PCN-20190109 TE0808-04-* SPI Flash Change

Company	Trenz Electronic GmbH
PCN Number	PCN-20190109
Title	TE0808-04-* SPI Flash Change
Subject	BOM change
Issue Date	2019-07-15

This change affects Trenz Electronic TE0808-04 SoMs: TE0808-04-*

Locate Flash (U7, U17) on bottom side of PCB:

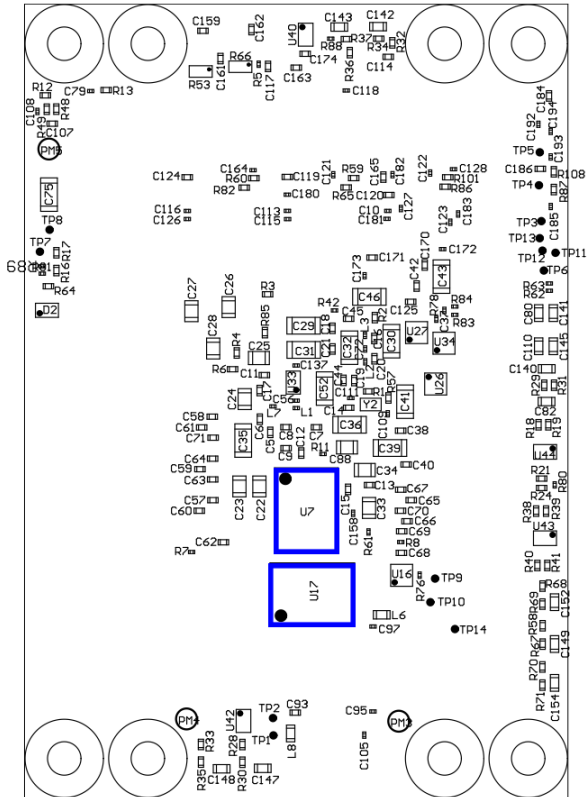
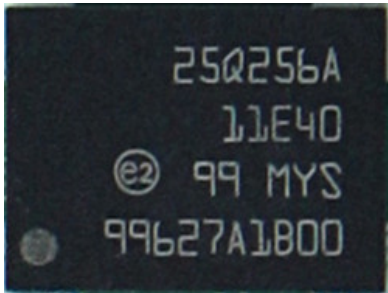
#1 Change SPI Flash from N25Q512A11G1240E to MT25QU512ABB8E12-0SIT

Reason: N25Q512A11G1240E became obsolete.

Impact: None. Both have same JEDEC ID BB20h and manufacturer ID 20h.

old	new
N25Q512A11G1240E	MT25QU512ABB8E12-0SIT
